Audit Report

OFFICE OF THE INSPECTOR GENERAL

**CONSTRUCTION PROJECT FOR THE CONSOLIDATED
EDUCATION AND TRAINING FACILITY AT THE
U.S. AIR FORCE ACADEMY**

Report Number 93-003

Comparison of Existing Space
(Excluding Research Space)

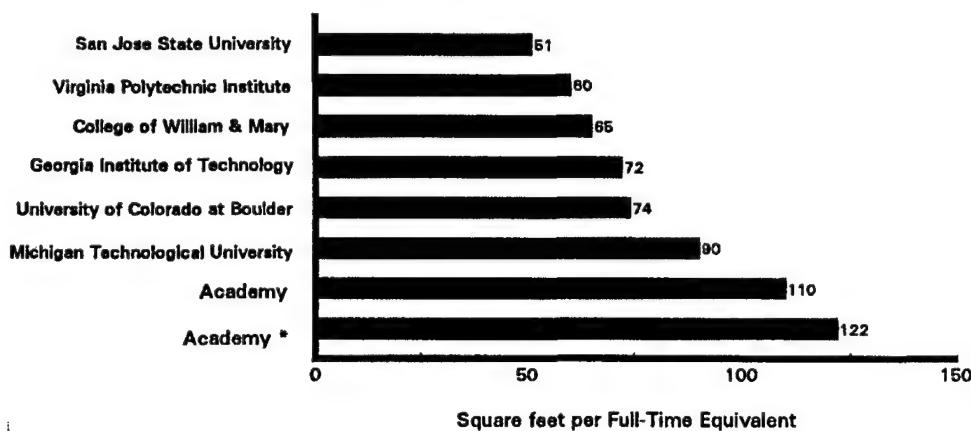
To accurately compare academic space at the four universities to the academic space at the Academy, we obtained actual assigned space per FTE student from facility planners at those universities. We compared only existing academic space at the schools and excluded research space. Also, we included in our comparison the College of William and Mary and the Virginia Polytechnic Institute and State University. Data on the Virginia Polytechnic Institute and State University were obtained from the Council on Higher Education, Virginia. The comparison of existing space is shown in the graph below.

As shown above, the Academy has more academic space than other larger institutions. Once cadet enrollment is reduced to 4,000, the assigned square feet per FTE student will be even greater.

Comparison of Existing Classroom Space

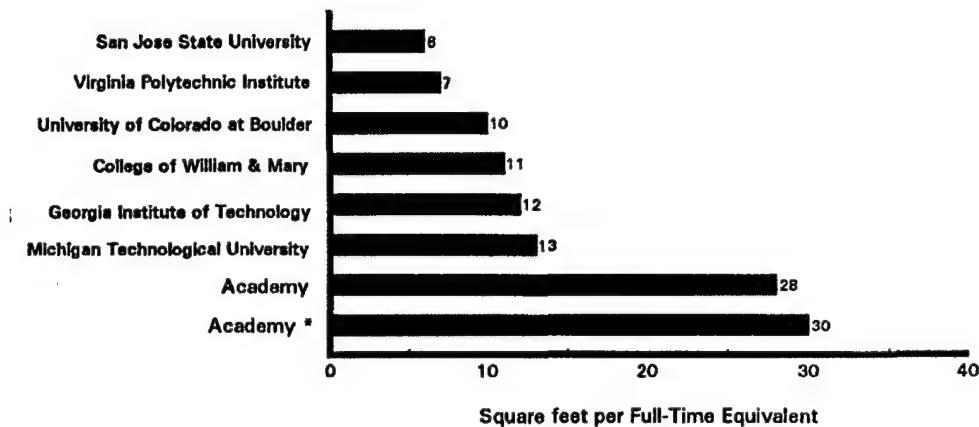
We also compared the assigned square feet per FTE student for classrooms and laboratories. The following graphs show the existing instructional space per FTE student at the Academy as compared to other institutions.

As shown, the Academy has more than twice the classroom space per FTE student than some of the other institutions depicted. The Academy's existing laboratory space is equivalent to that of the Georgia Institute of Technology, a leading research institution. Moreover, when the Academy's enrollment decreases to 4,000 cadets, it will have more laboratory space per FTE student than the Georgia Institute of Technology. Facility planners emphasized the efficient use of existing facilities rather than construction of additional space.
